New and Improved ICC Voice/Data Modular Connectors

La Mirada, CA— October 23, 2009

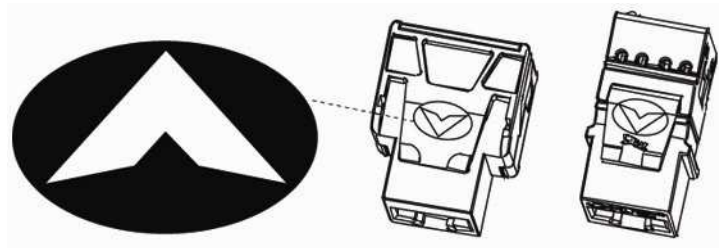
In an effort to improve performance and streamline termination of voice and data modular connectors, ICC has made some changes to the wiring scheme along with changes to the housing. CAT 5e, CAT 6 and CAT 6a modular connectors now all have the same pair-to-pair wiring scheme for improved performance. In addition, the IDC height has been increased for easy wire placement and improved cable retention. Since both voice and data modular connectors now have the same housing, a brand new 4-pair combo termination tool will be made available soon for terminating both EZ/HD voice and data connectors. No more carrying around different tools for each kind of connector. (Single blade punch-down tool* can still be used for termination.)
